**Re: Response to Review Comments – Preliminary Subdivision
Anglers Road Commons Apartments
Anglers Road Commons, LLC. – Applicant/Owner**

Review Comments – April 11, 2019 email:

**DRAW DOWN
TIME RANGE**

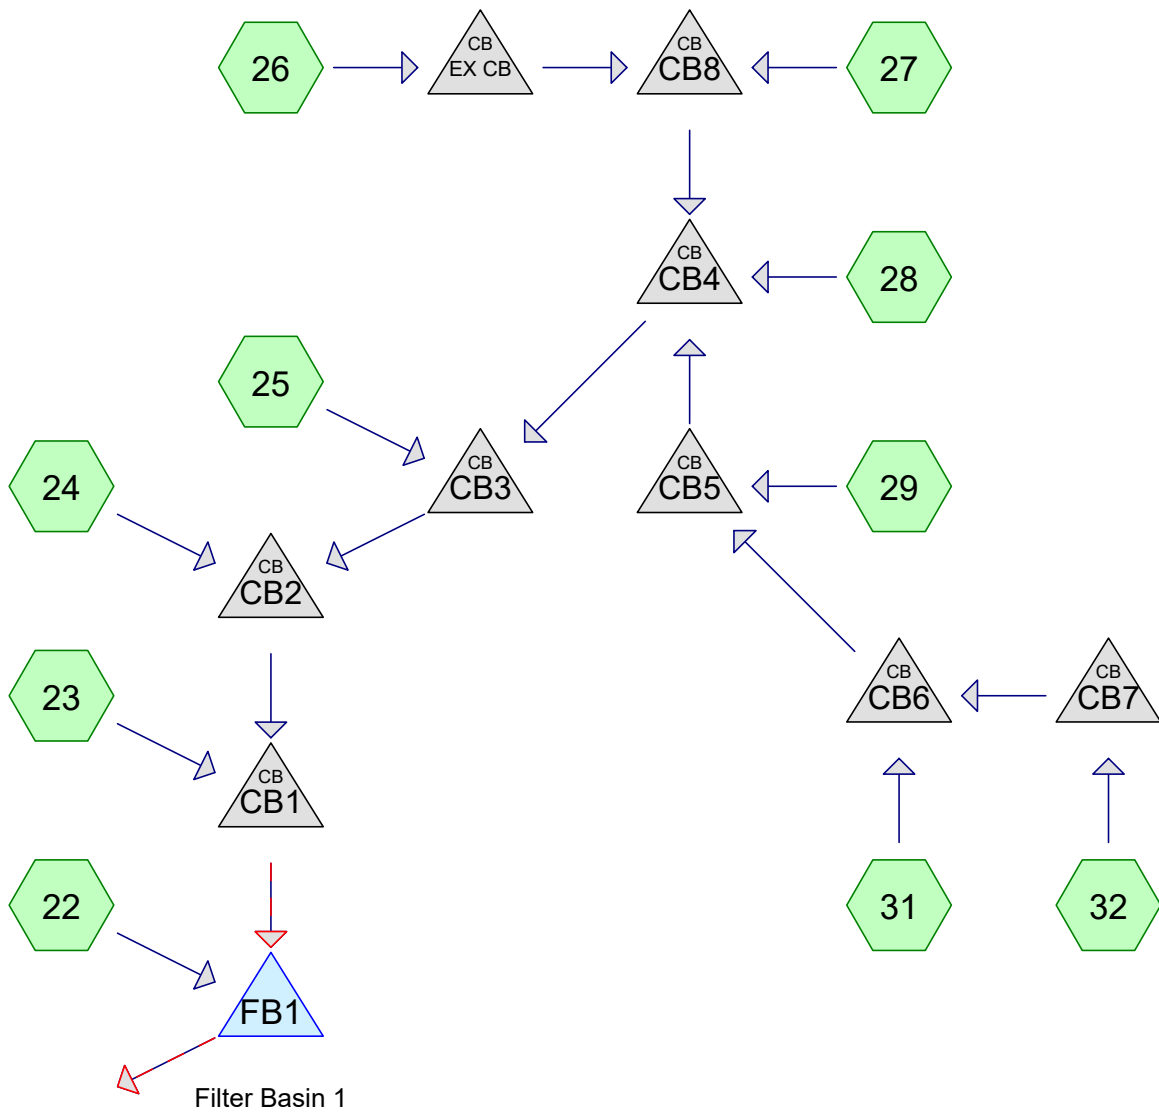
13. Verify that the water quality volume will be released from the filter basin in 24-48 hours as recommended by Maine DEP BMPs.

RESPONSE: In Attachment 3 of the revised storm water management report, output data from the hydrologic/hydraulic modeling of the project evaluating the proposed filter basin in the 2-year storm event illustrates the proposed pond design's provides the required draw down time.
